**Longyuan Pingtan Wind Power Co. Ltd**

Please find below our responses to the issues raised by requests for review of the "Project 1177: Fujian Pingtan Changjiang'ao 100 MW Wind Power Project".

Figure 1: Sensitivity analysis of the project

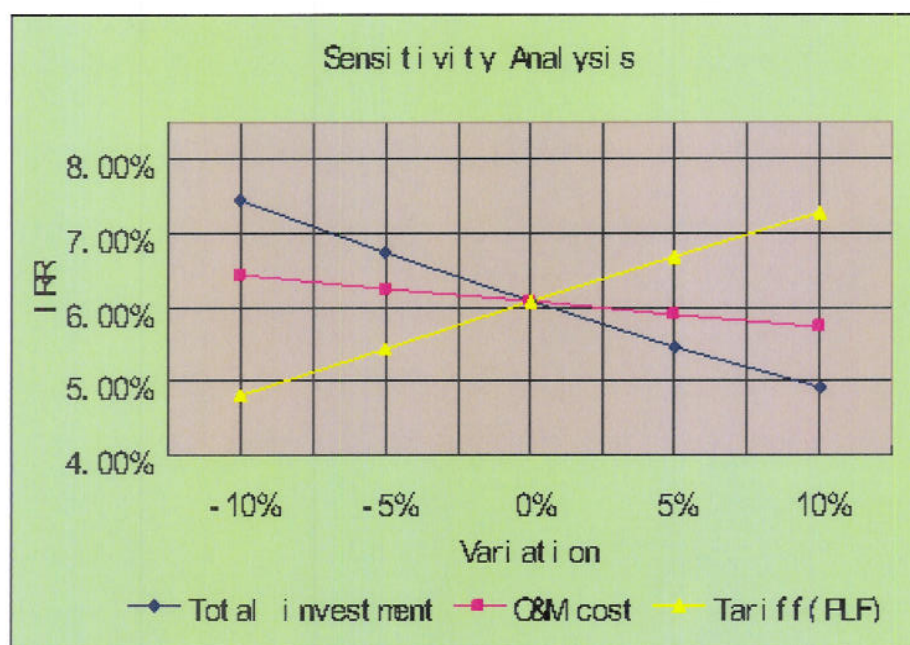
- It is not clear from the PDD or validation report if the system PLF could be higher or lower than 30% and its effect in the project financing. The sensitivity analysis uses only Investment/MW, O&M and tariff. Information about the PLF is critical because it could generate uncertainty in this project.

Please find below the sensitivity analysis with a plus and minus 10% around the 30% PLF actually expected. The tariff negotiated ex ante is based on the 30% PLF assumption. It shows the sensitivity around the PLF is similar to the sensitivity around the tariff (both impact the turnover the same way).

According to the Chinese Renewable Energy Law enacted on January 1<sup>st</sup> 2006, wind power generation should be purchased fully by the grid. Therefore, the PLF reflects the annual generation output of the proposed project, which depends on the average wind speed at the

project site for a specific wind turbine. The needed PLF to reach the 8% benchmark is 17% higher than the basic 30% assumption. This is extremely unlikely considering the following fact that the average wind speed at the project site has been decreasing over the past 49 years (see Table 1).
